EXISTING 5TH FLOOR PLAN
RENOVATE ROBOTICS BUILDING
UNIVERSITY OF KENTUCKY

UK
 CPMD PROJECT #: 2353.0
 CONSTRUCTION DOCUMENTS
 30 MAY 2013

THE BIDDING AND GENERAL DOCUMENTS, TECHNICAL SPECIFICATIONS AND DRAWINGS ARE CHANGED IN ACCORDANCE WITH THE FOLLOWING. PLEASE SUBMIT A PRICE PROPOSAL BASED ON THE CHANGE ORDER INFORMATION AND ANY ACCOMPANYING DRAWINGS FOR APPROVAL AND INCLUSION INTO THE CONTRACT.

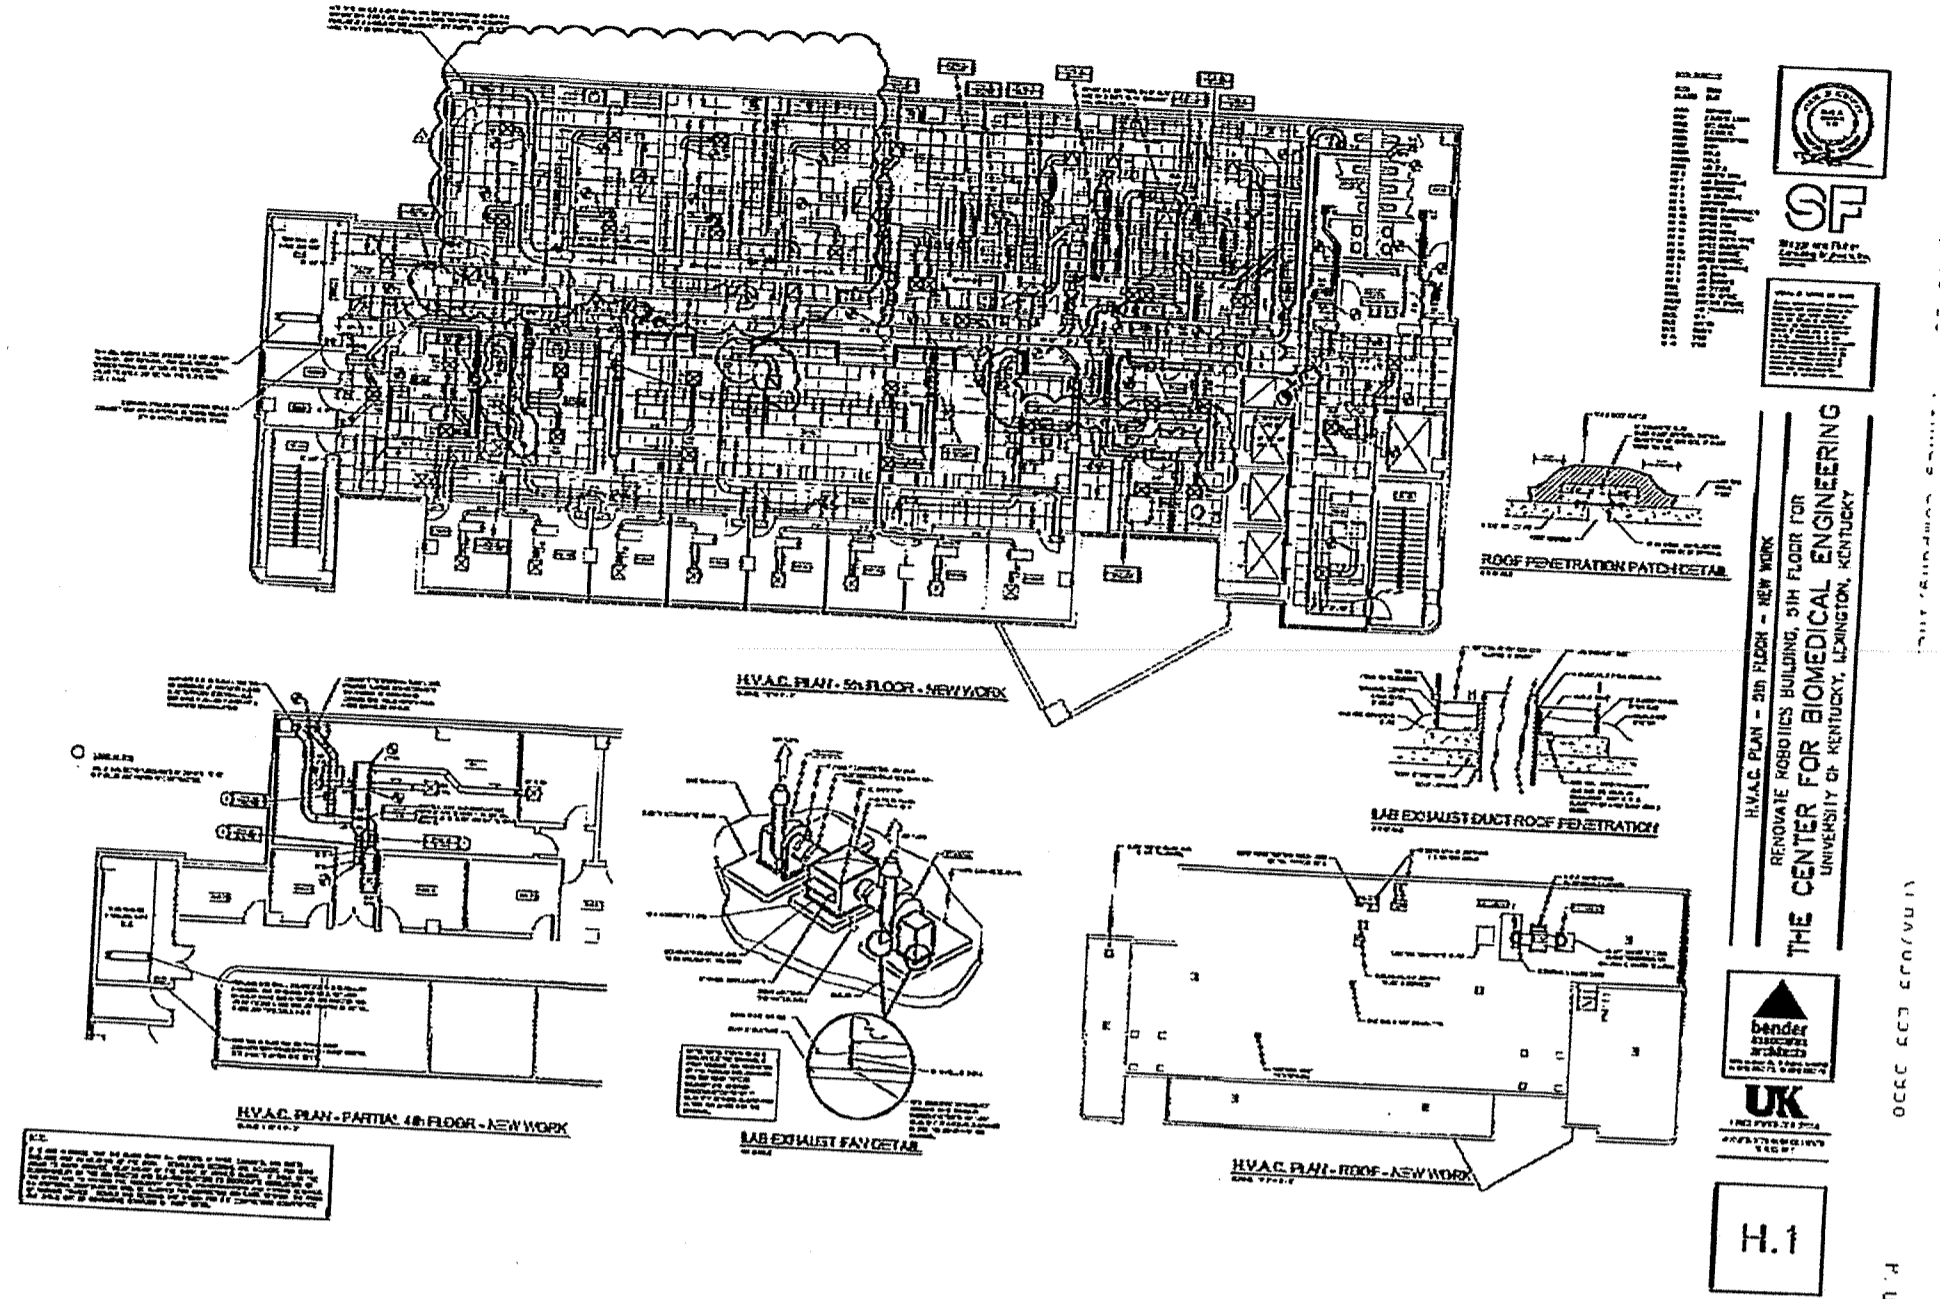
We propose to modify the fume hood exhaust system to accommodate future tie-in of hoods in Room 509 to 515 as follows:

1. We will relocate (4) existing VAV boxes forward to allow the revised exhaust duct to tie to the new existing duct running to the 4th floor. Mike Davis confirmed that he has allowed for this box relocation.
 2. We will make necessary modifications to existing inlet and outlet ductwork to the (4) boxes.
 3. We will reinstall the (8) diffusers that were removed during demolition of ceiling by Marillia's demo crew.
 4. We are allowing credit for the 14" round ductwork that has not been prefabricated.
 5. Add (5) exhaust grills and their ductwork per original change order plan
- \$ 19,640.00

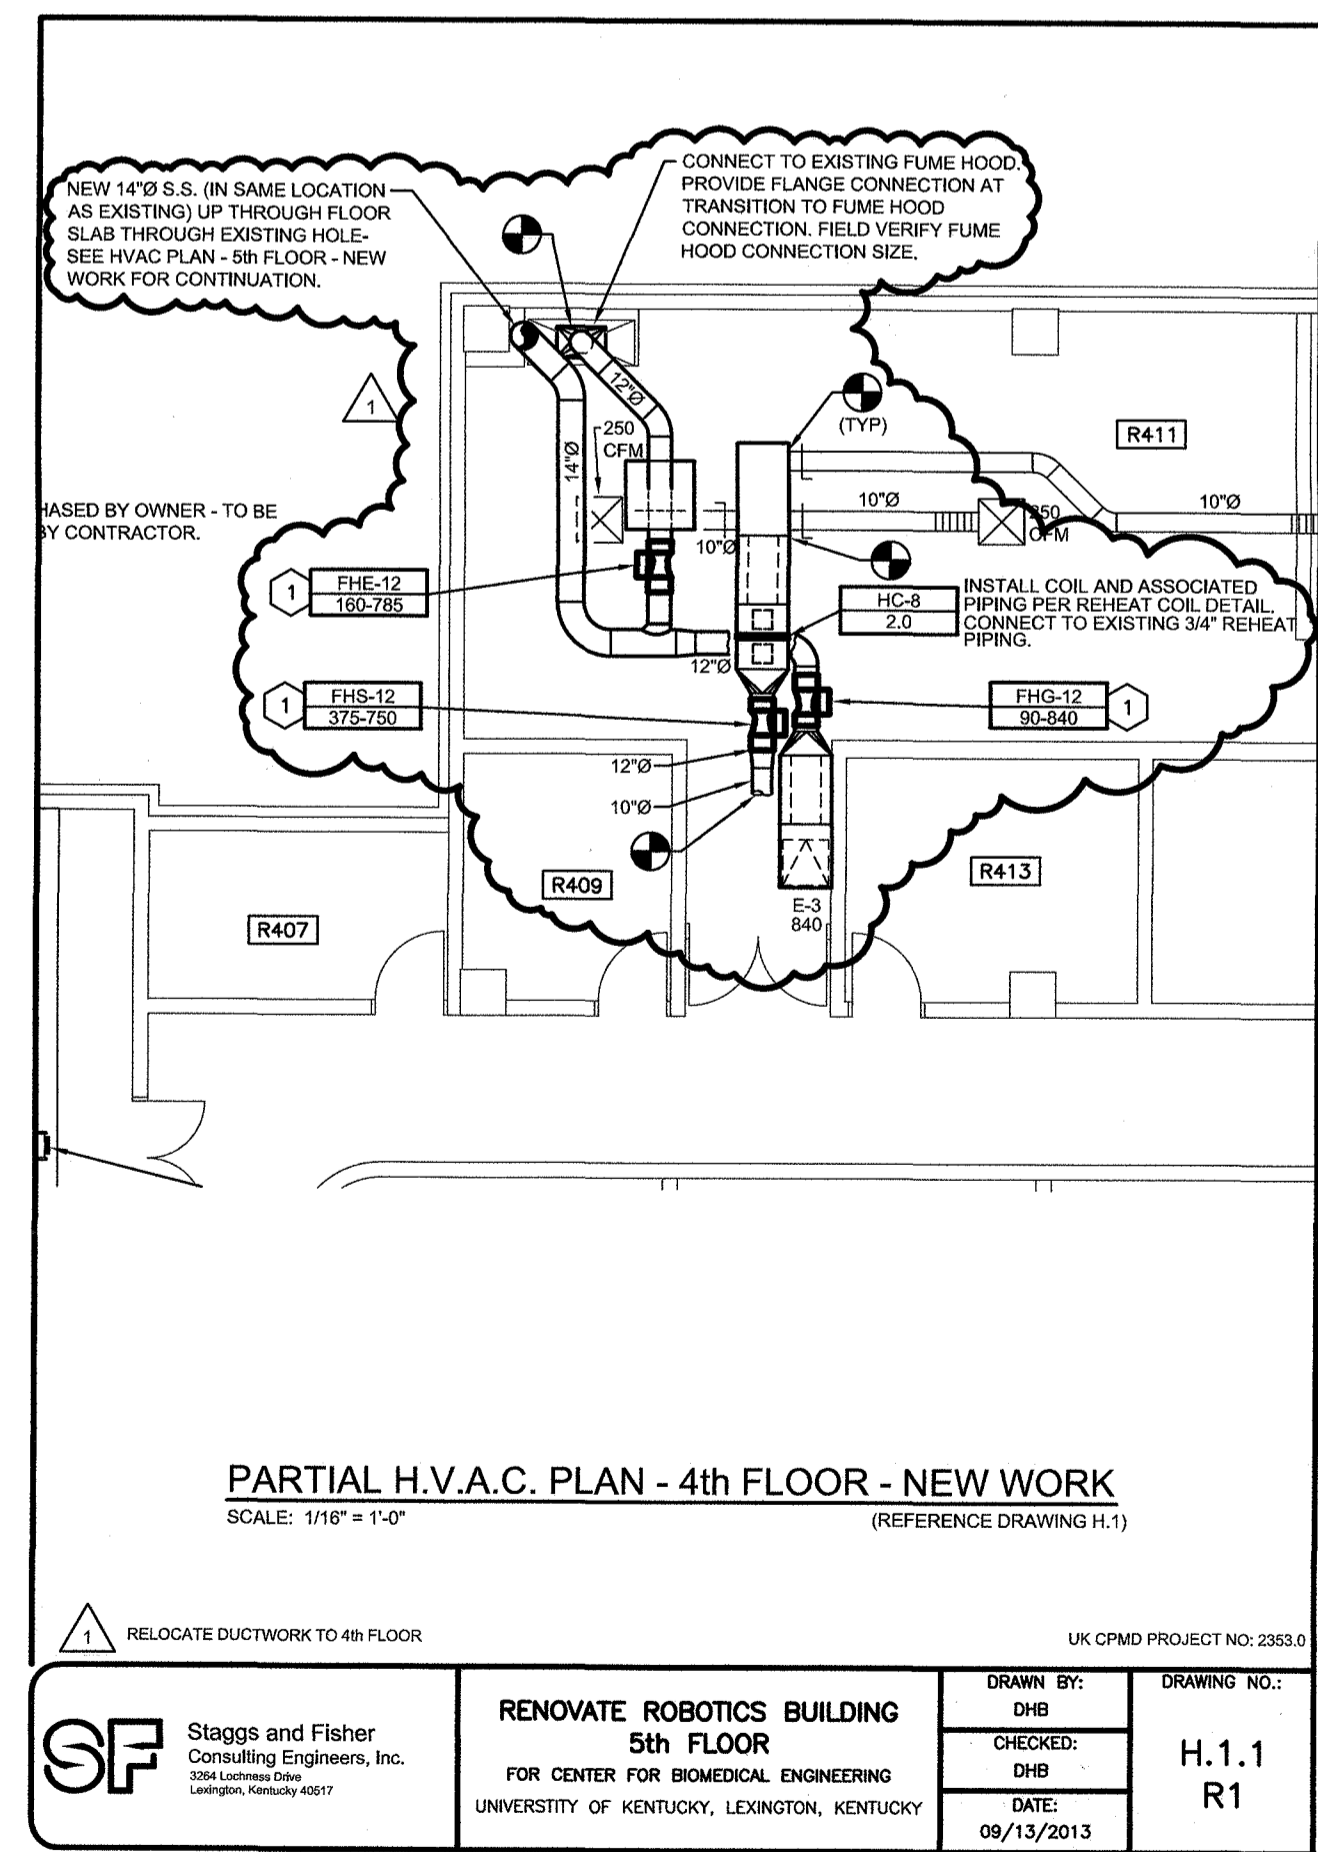
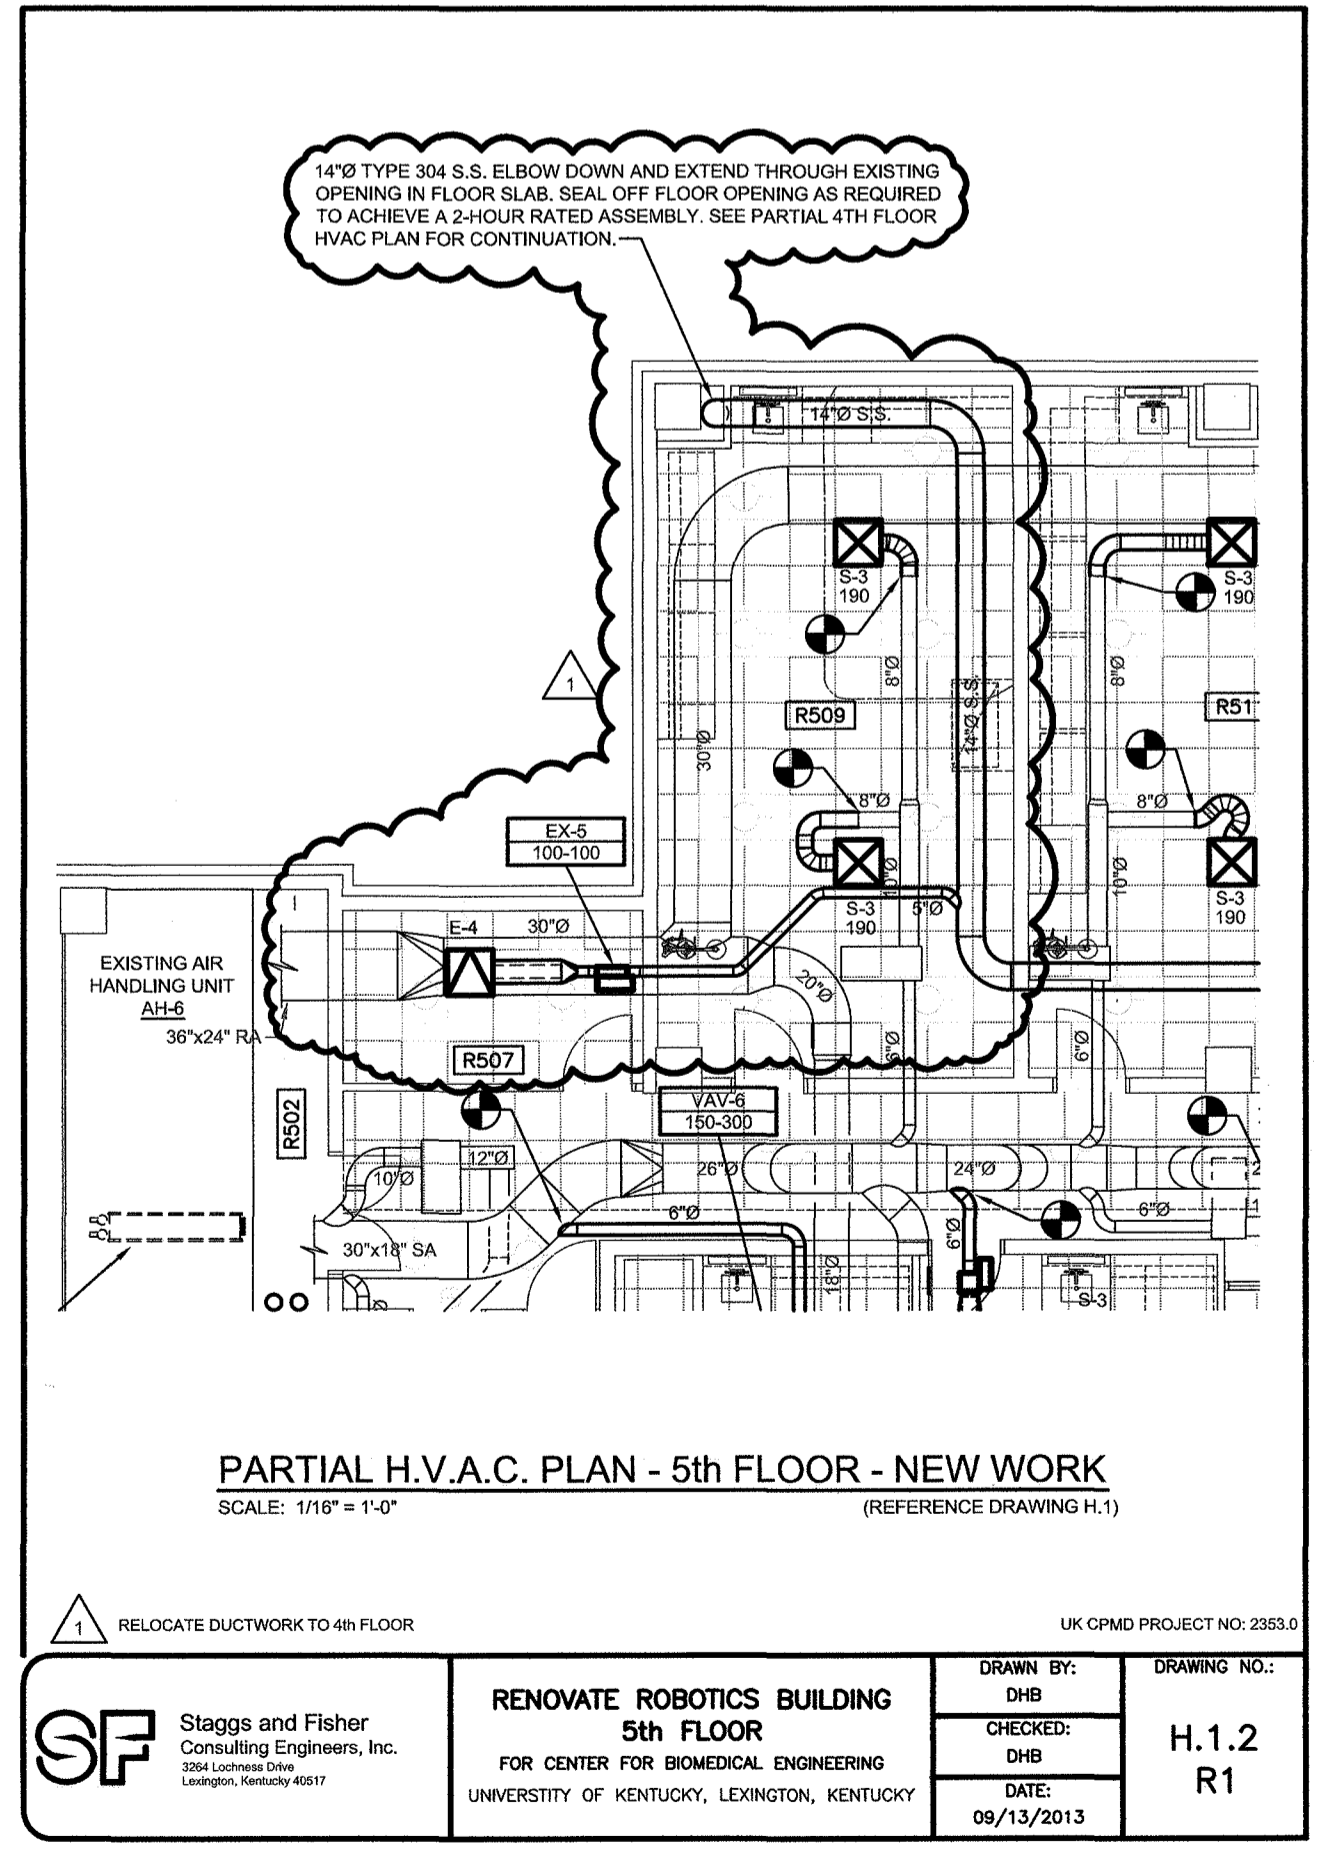
MECHANICAL
See attached Revised Mechanical Plan H1.1R4. Please price the following:

1. Route new 2" copper ventilation pipe above ceiling as shown on plan.
2. Copper pipe to extend down chase space in Lab R511 through the floor and extend 12" below the slab. UK PPD will make the final connections in the 4th floor lab.
3. Provide Greenheck CSP-B10, 0.62 amps, provide 120 volt. Provide transition from fan to 2" copper pipe. Seal all connections.
4. Connect 2" copper discharge pipe from fan to existing vent through roof.

ELECTRICAL
See attached Revised Electrical Plan E1.3R1. Please price the following work:

5. Provide power to new ventilation as shown.
